PREVOST

**WARRANTY
BULLETIN**

WB17-10B

DATE :	June 2017	SECTION :	26 SLIDE-OUT
EXPIRATION:	June 2019		
SUBJECT :	SLIDE-OUT RAIL BOLT INSPECTION

Figure 3

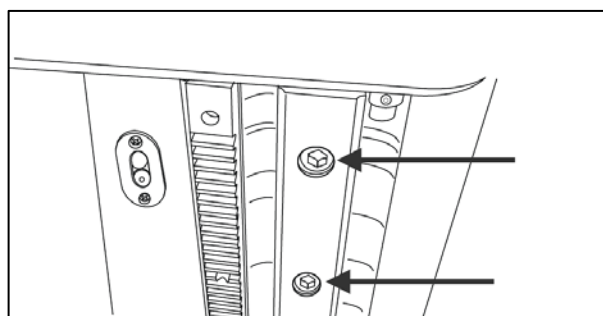
1. Extend the slide-out room.
2. Set the ignition switch to the OFF position and trip the main circuit breakers equipped with a trip button.
3. From under the slide-out, locate the slide out rail socket head screws. (Fig. 3)
4. Remove the protecting cap.

5. Re-torque to **90-100 lb-ft (122-136 Nm)**.

Perform this only on accessible rail screws.

Figure 4

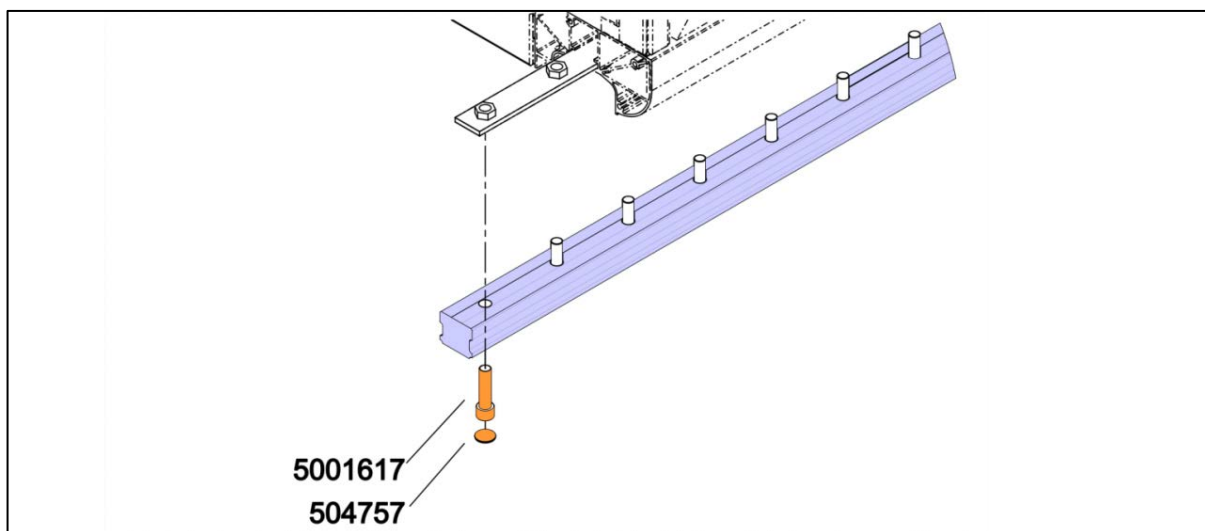
6. If the screw head is broken, use a bolt extractor kit to remove the bolt. Closely follow kit instructions.
7. Replace with a new 5001617 screw (Fig. 4). Tighten to **90-100 lb-ft (122-136 Nm)**.

Note that kit WB17-10 includes additional screws for a replacement of visible screws on the longest slide out configuration.
8. Replace any missing or damaged finishing plugs with replacement plugs #504757 supplied in the kit.(Fig. 4)
9. Finishing plug should be mounted flush with rail surface to avoid inflatable seal damage.
10. Set breakers and ignition switch back on.
11. Confirm proper slide operation.
